SUBJECT: HANFORD TRIP REPORT ON HYDROLOGIC MODELLING

Subject: TRIP REPORT--BWIP Site Visit

SUBJECT: Visits to PNL and RHO (Richland) and to
USGS (Tacoma), 8/21 - 28/81.

Figure 1. Regional features at the Columbia Plateau (from PNL slides).

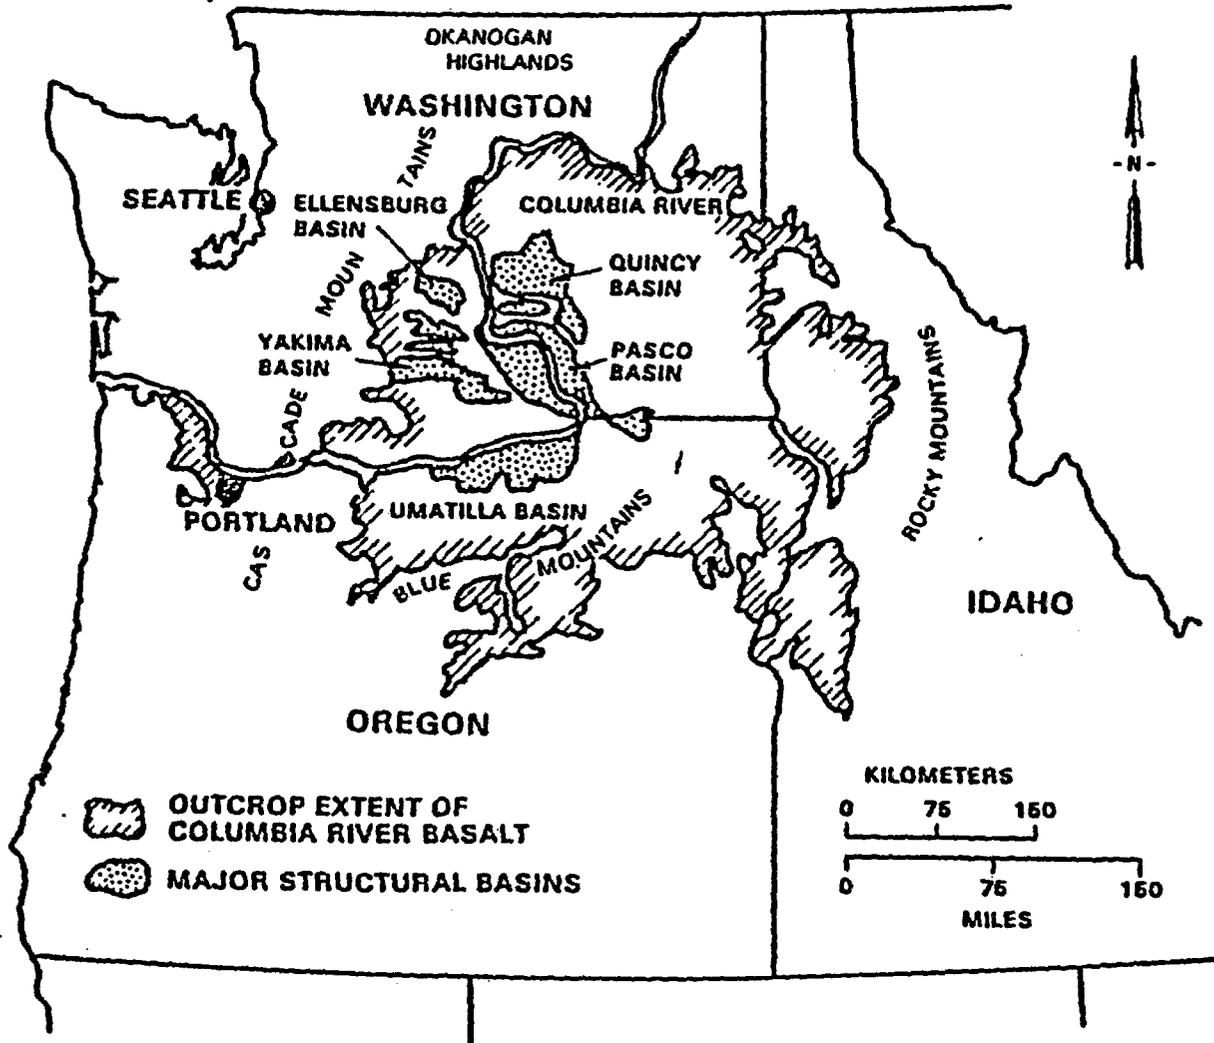
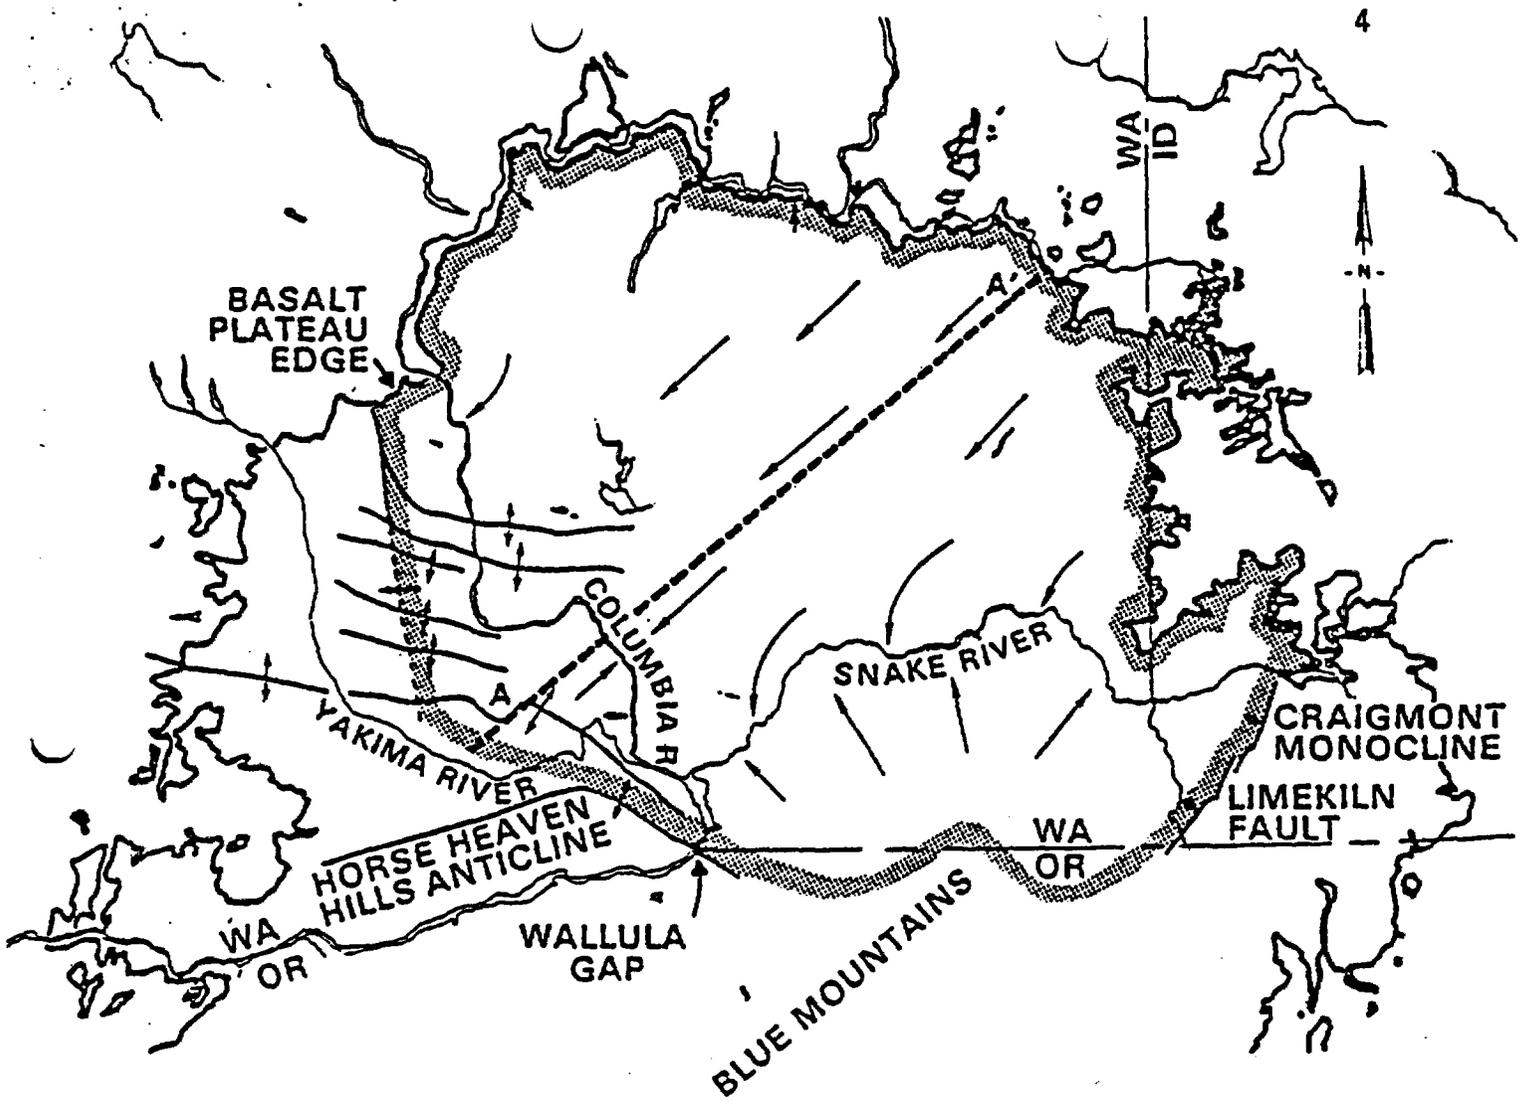
The regional model was constructed to estimate flows and boundaries for the local or Pasco Basin model. It is similar to a modeling study performed by the U.S. Geological Survey, known as a coarse grid model that is used to estimate interbasin transfer. The region included in this study is shown in Figure 1. The finite-difference grid of the regional model had two active layers. The lower-most layer represented the Grande Ronde Formation (the Umtanum unit in the middle of this formation is the site of the proposed repository). The next layer represented two formations: the Saddle Mountain Basalts and, primarily, the Wanapum Basalts. An upper third layer was used in the model, but was not active (not part of the solution). Its purpose was to represent the alluvium (Ringold Formation). Where the alluvium was present or

Figure 3. Pasco Basin boundaries (from PNL slides).

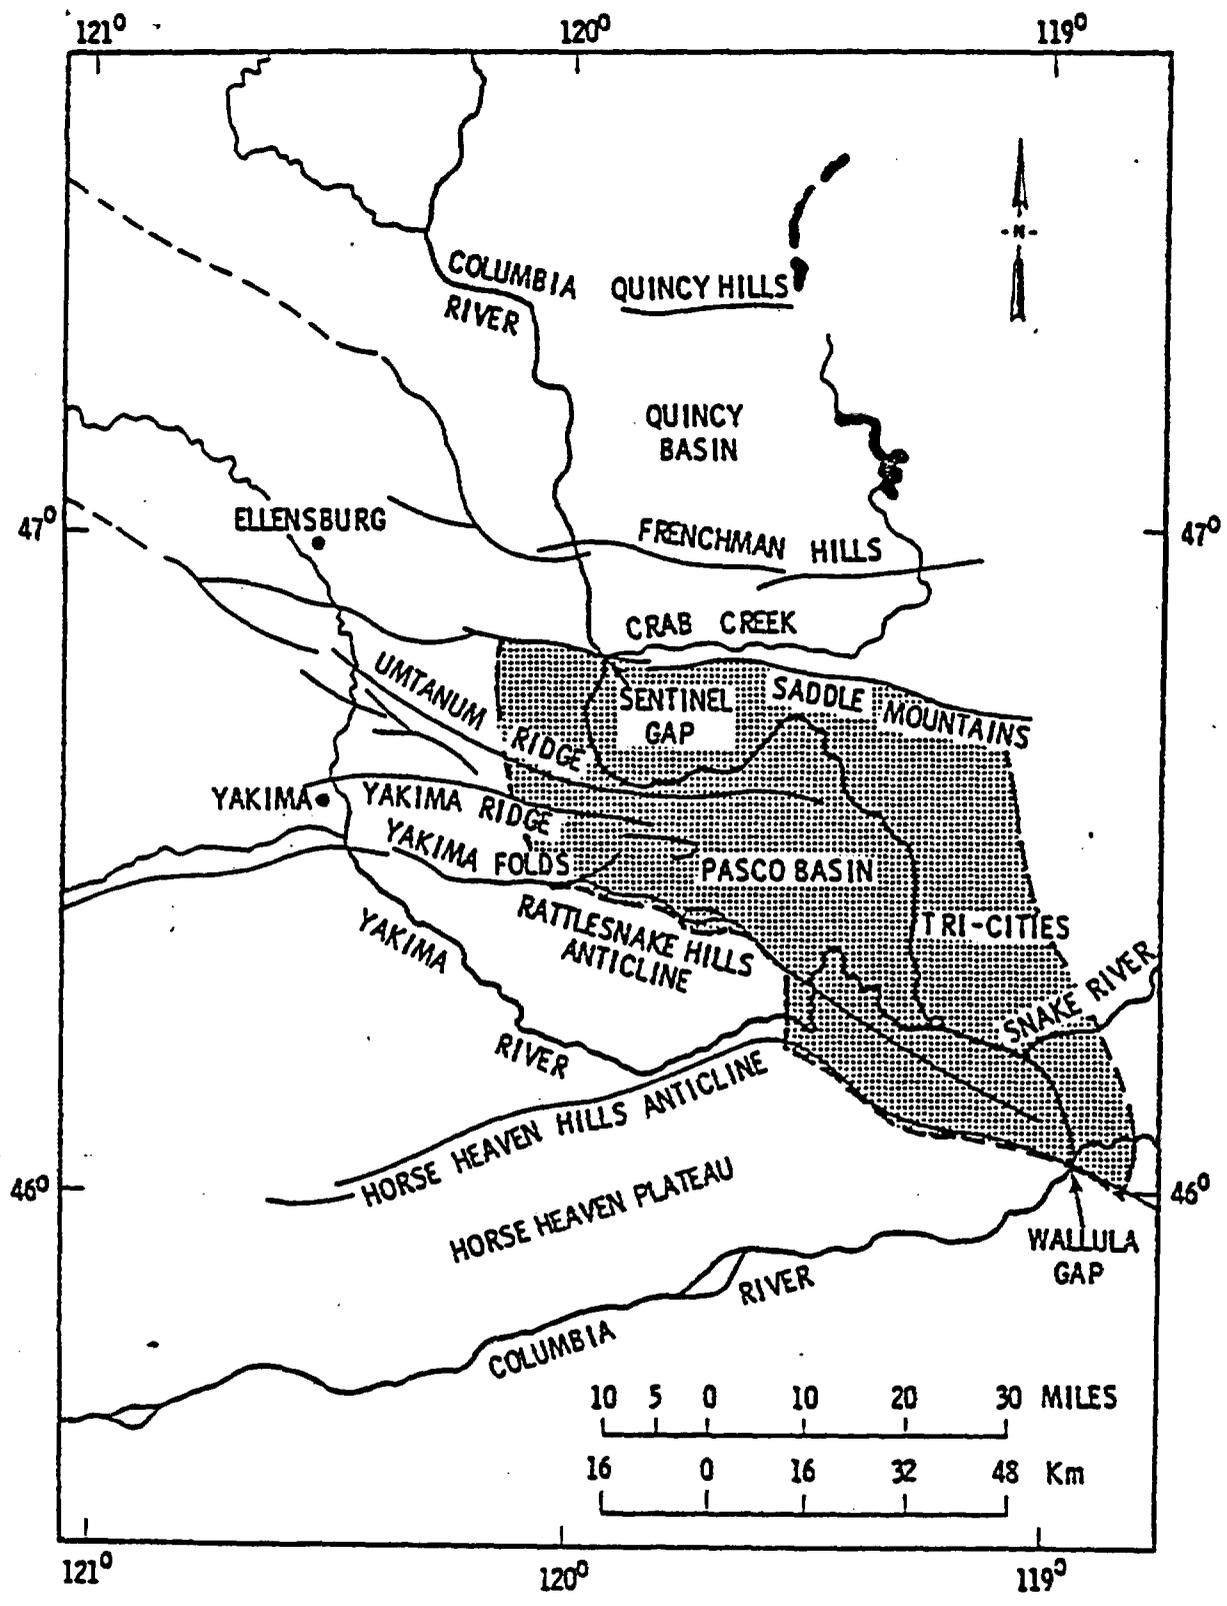
The regional model was used to help define the local model of the Pasco Basin. The model used in this case was a three-dimensional finite-element code. There were three active layers, where again, the alluvium was treated as a Dirichlet boundary. The local model boundaries were somewhat arbitrary and are shown in Figure 3. The finite-element grid is shown in Figure 4. The boundary conditions for the boundaries that are common to both the local and regional models are treated as described before in the regional model. For the other boundaries, the Rattlesnake Hills were treated as no-flow (a

Figure 4. Pasco Basin finite element configuration (from PNL slides).

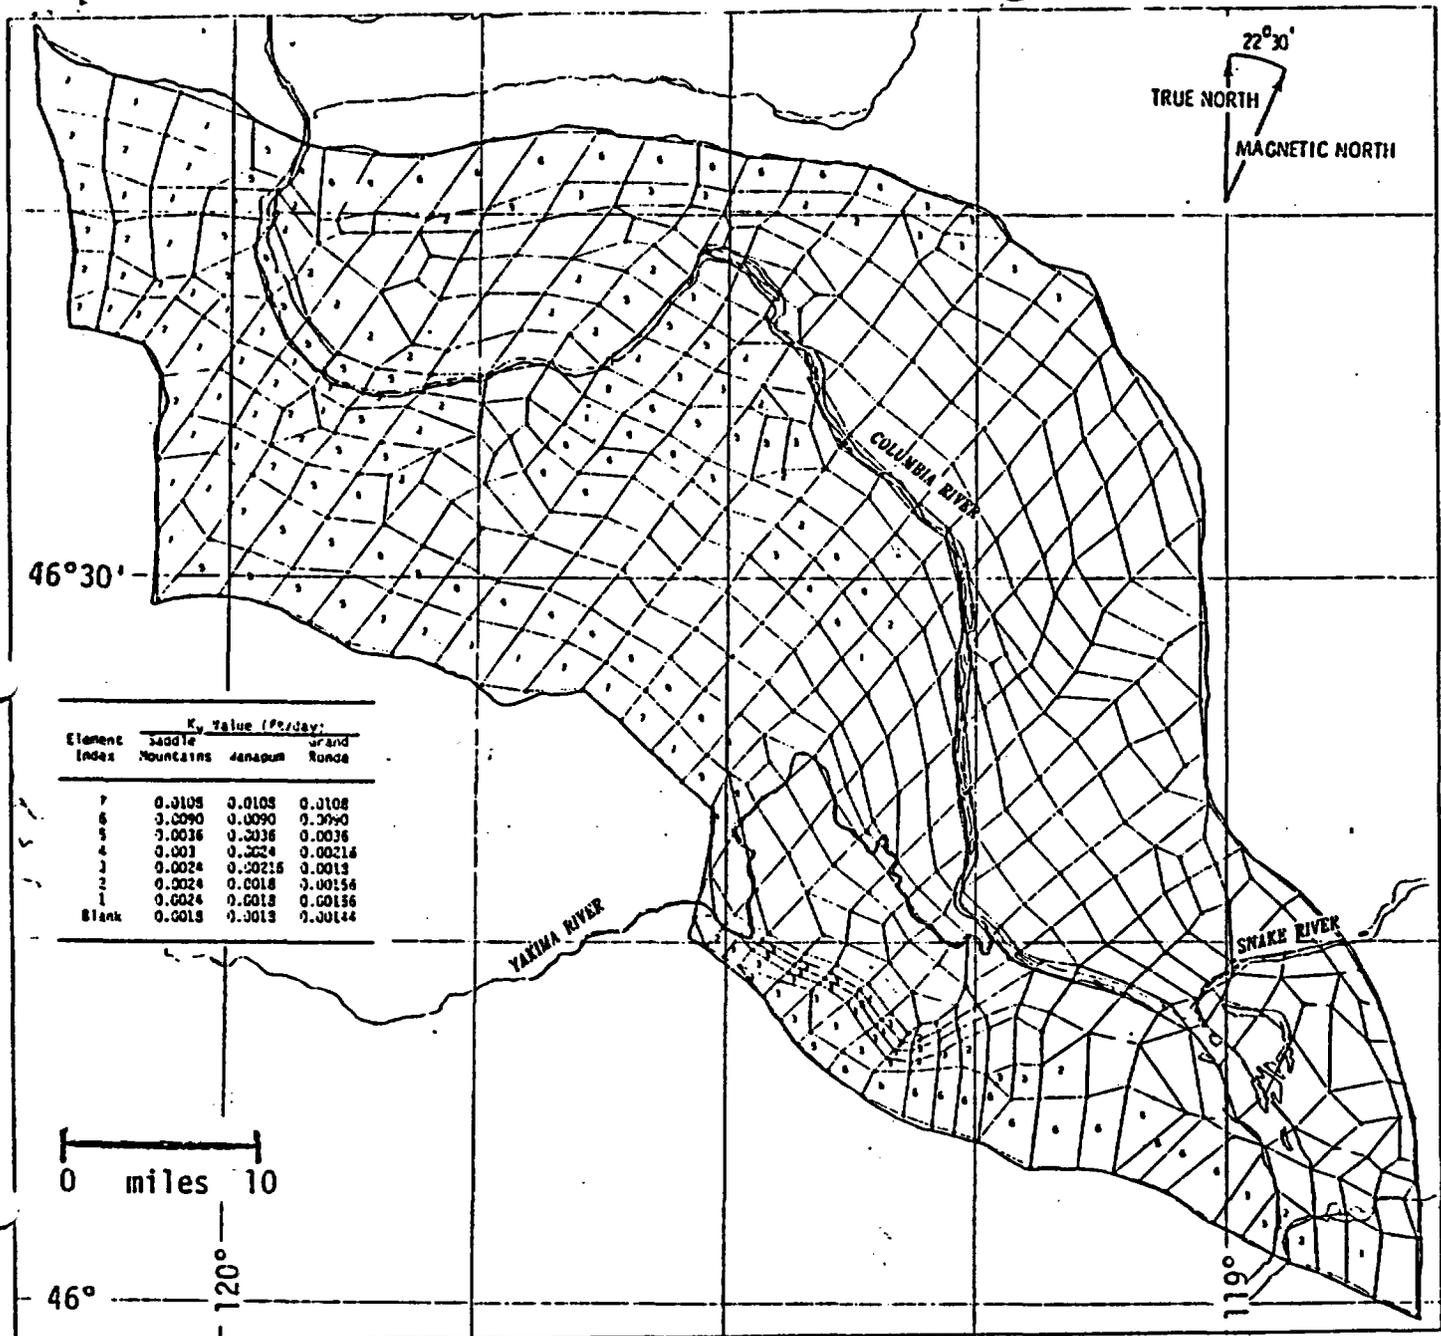
ground-water divide), whereas the remaining boundary was treated as constant head, determined from the regional model. Since the regional model was a two-layer, finite-difference model, and the local model was a three-layer, finite-element model, some type of extrapolation had to be used to obtain the appropriate head values for the constant head boundaries. Several approximations were used, with all being fairly insensitive to the computed travel time, since the path line was mainly in the vertical. As part of the modeling, anticlines were assigned a higher vertical hydraulic conductivity and a lower horizontal hydraulic conductivity than the surrounding rock. Details of the parameters used in the local model are given in Table 3 and on Figure 4.

The approach taken by PNL, that of using a regional model to help define the local boundaries and boundary conditions, is a good one. Since limited data are available, this modeling effort is considered preliminary, and a simple model with few layers is justified. In fact, because of the scale of the regional model and the limited data, a one layer model probably would have been adequate. This is supported since they had to lump the Saddle Mountains and Wanapum Basalts into one layer, while for the Grande Ronde layer, they had to assume similar hydrologic properties to those of the Wanapum Formation. Why not treat all as one layer with leakage? For the local model, more layers are justified since the goal is to calculate travel times.
